Staff Report for Administrative Approval – Hillside Review – Notice of Approval

Weber County Planning Division

Application Request: Consideration and action on a request to approve a Hillside Review for Turner Residence Lot 65R in the Causey Estates Subdivision.

File Number: HSR 2019-01

SD1

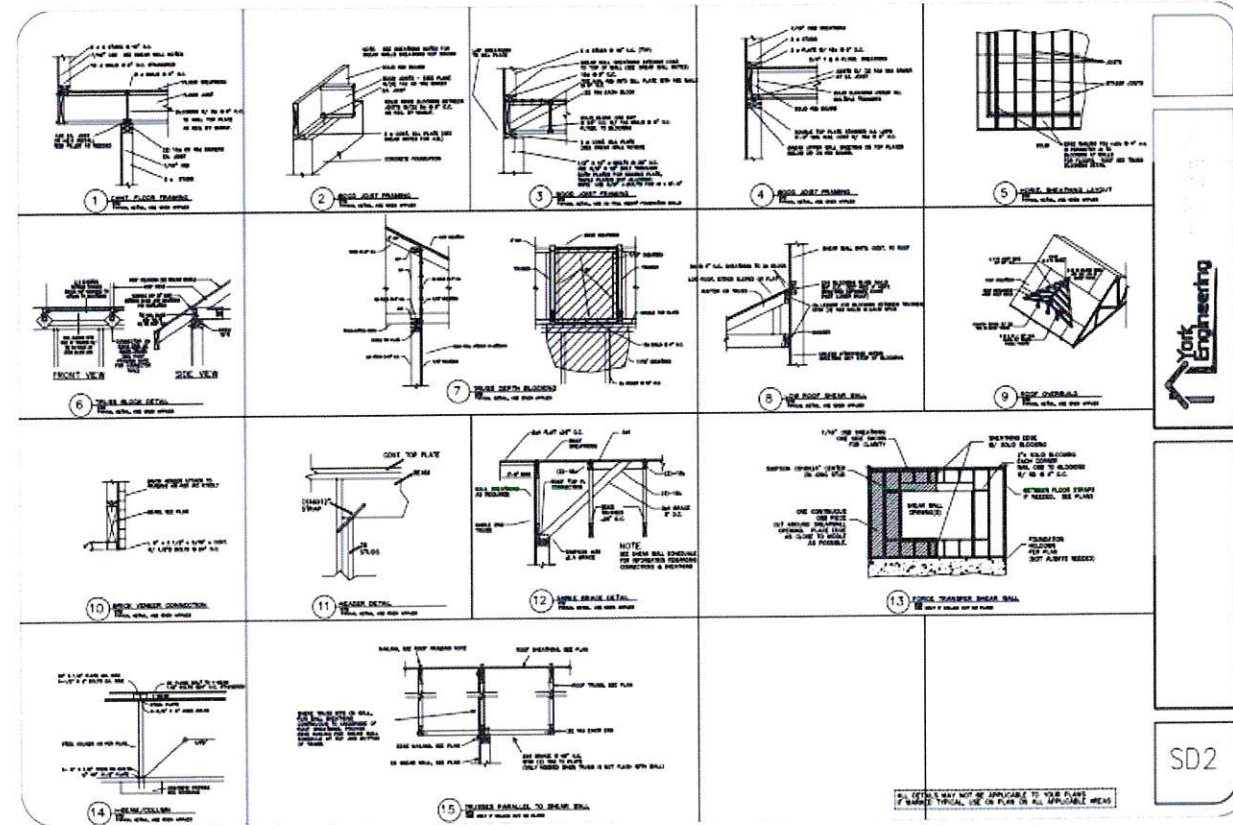
1. Show the proposed finished contours on the site plan.
2. The 4' retaining wall will need to be engineered.
3. All recommendations contained in the submitted Geologic Hazard Study dated 11/23/2018 must be followed
